Access Compliance Report

Public Rights-of-Way

(Curb Ramps)

Intersection ID: 13404	Main Street: LEXINGTON_AV	Cross Street: E_CARSON_BV	Location: SE
ADA ID: A81B7B9285F5	Ramp Type: Perp	Initial Pass/Fail: Fail	Overall Compliance: No
Severity Score: 10			
Codes/Mitigation Info/Possible Solution		Field Measurements/Component Compliance

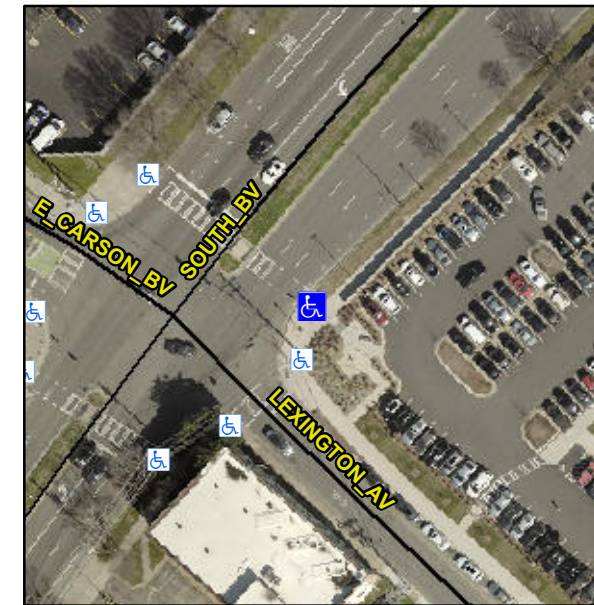
R304.5.1, R304.5.3

Compliance	Description	Data	Compliance	Description	Data
N/A	Ramp Length (in)	96.0	Yes	Ramp Slope (%)	6.0
No	Ramp Width (in)	45.5	No	Ramp XSlope (%)	3.3
N/A	Flare Type LT	N/A	N/A	Flare Type RT	N/A
N/A	Flare Slope LT (%)	N/A	N/A	Flare Slope RT (%)	N/A
N/A	Flare Traversable LT?	N/A	N/A	Flare Traversable RT?	N/A
N/A	Landing Length (in)	N/A	N/A	DWS Provided?	N/A
N/A	Landing Width (in)	N/A	N/A	DWS Contrast?	N/A
N/A	Landing Slope (%)	N/A	N/A	DWS Length (in)	N/A
N/A	Landing X Slope (%)	N/A	N/A	DWS Full Width?	N/A
N/A	Landing Curb? (Y/N)	N/A	N/A	DWS Offset (in)	N/A
N/A	Shared Landing?	N/A			
N/A	Gutter Ponding?	Yes	N/A	Gutter Slope (%)	N/A
N/A	Gutter Lip Ht (in)	N/A	N/A	Gutter X Slope (%)	N/A
N/A	Painted X Walk1?	Yes	N/A	Painted X Walk2?	N/A
	X Walk 1 Direction	To NW		X Walk 2 Direction	N/A
N/A	X Walk 1 Width (in)	112.0	N/A	X Walk 2 Width (in)	N/A
	X Walk 1 Slope (%)	1.1		X Walk 2 Slope (%)	N/A
	X Walk 1 X Slope (%)	0.5		X Walk 2 X Slope (%)	N/A

Remove & Replace Entire Ramp.
